**Re: Letter of Notification of PPL Electric Utilities Corporation, Filed Pursuant to 52 Pa. Code Chapter 57 Subchapter G, for Approval to Re-terminate Approximately 600 feet of the Existing Lackawanna-Shickshinny 500 kV Transmission Line in Blakely Borough, Lackawanna County, Pennsylvania
Docket No. A-2018-2647063**

**PPL Electric Utilities Corporation
Response to Data Requests of
The Bureau of Technical Utility Services
Dated February 22, 2018
Docket No. A-2018-2647063**

PROPOSED B7-76 - MONOPOLE - 198' + REVEAL ABOVE GRADE

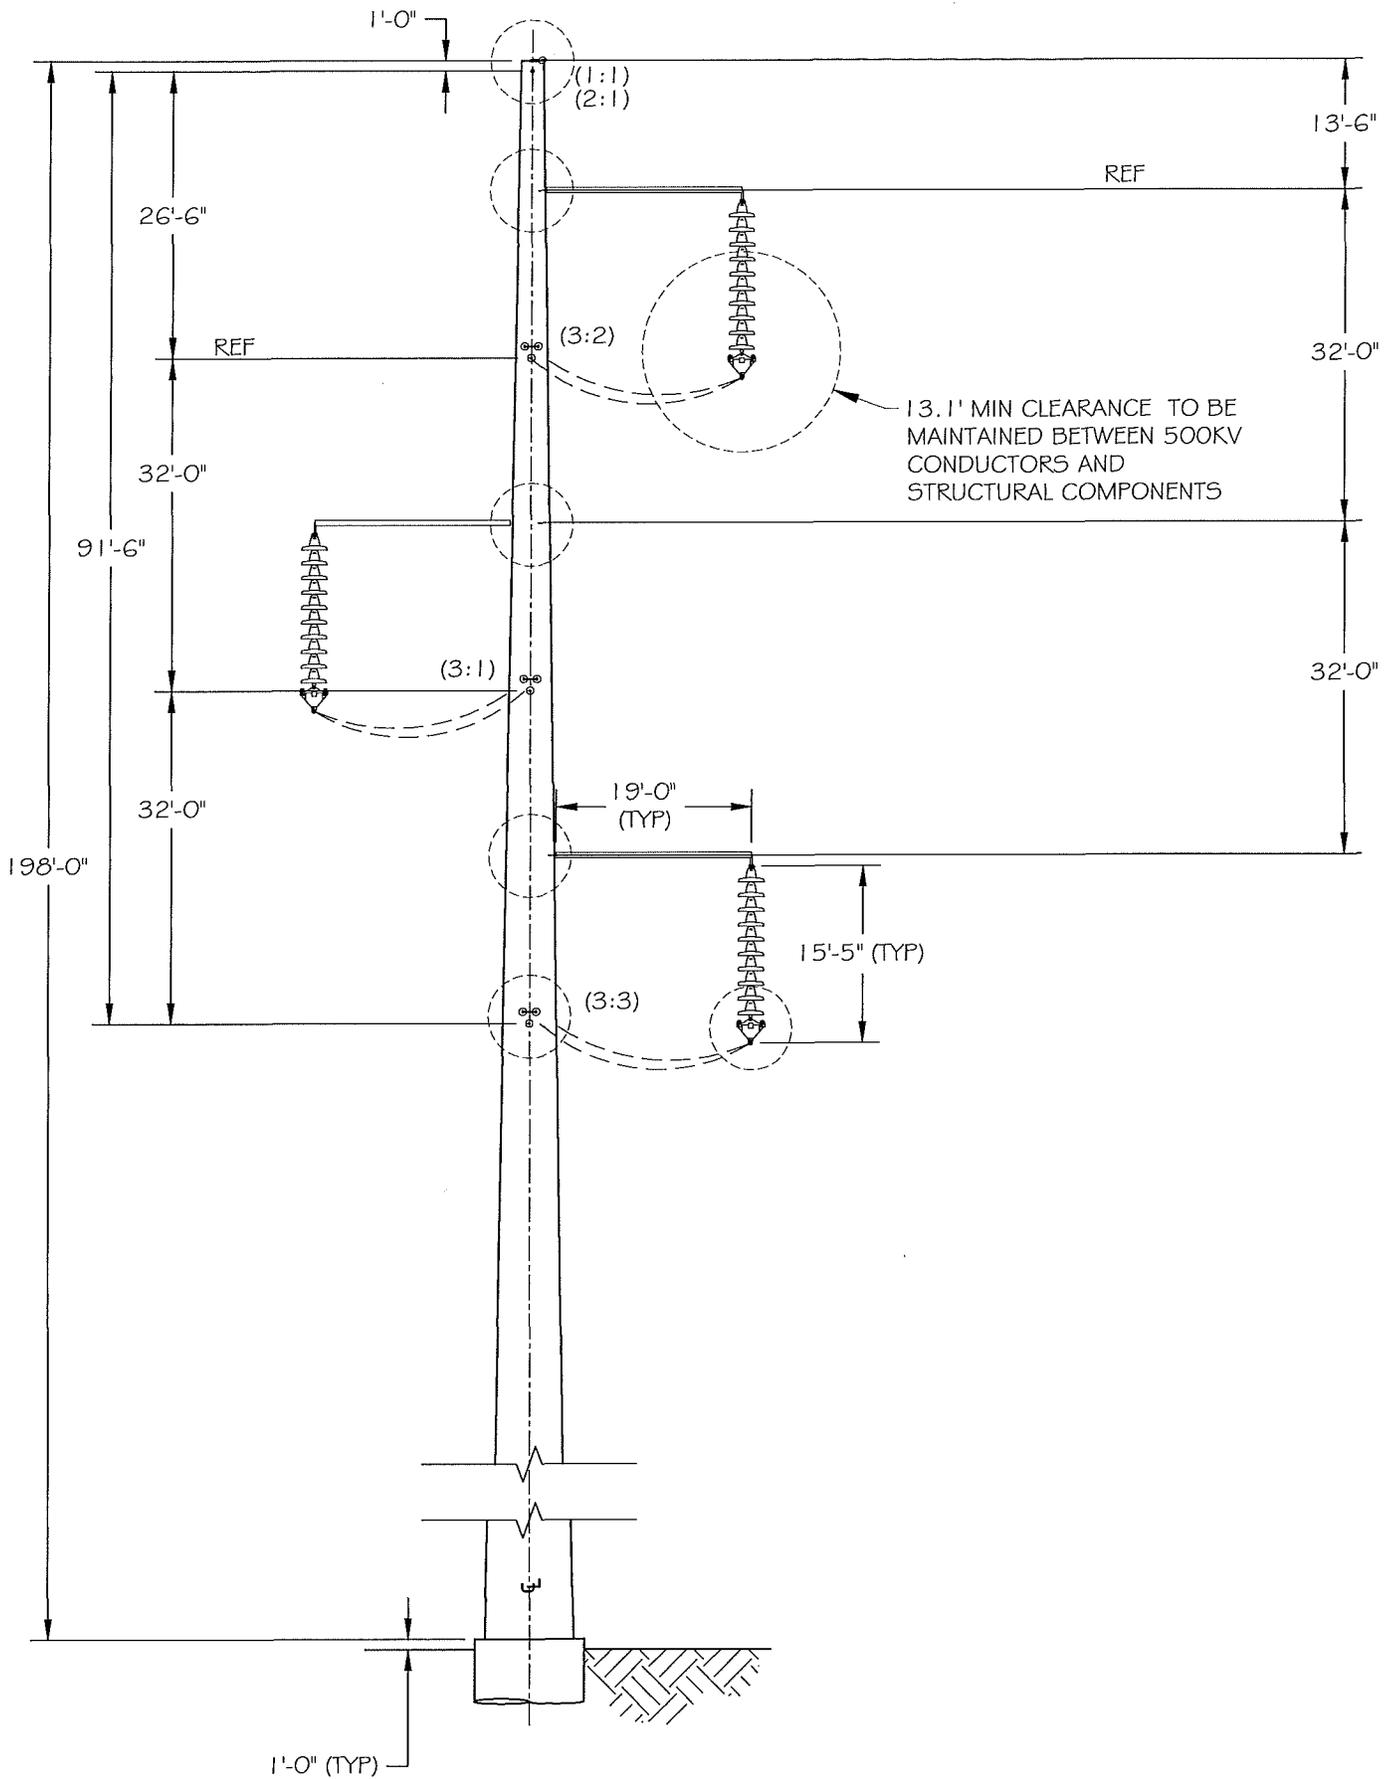
Q.3 Reference the Letter of Notification, Attachment 2, Pages 2-3 – Please state the height of existing nearby transmission tower structures.

A.3 The existing nearby transmission tower structures range in height from 174 feet to 195 feet (see Attachment A.3, structures B7-74 left and right and B7-75 left and right). Additionally, due to recent revisions to the project design, the new structure will be higher than presented in the February 22, 2018 LON. The height of the new structure will be 198 feet, rather than 160 feet as stated in the LON. A revised structure drawing is provided in Attachment A.3 (see structure B7-76).
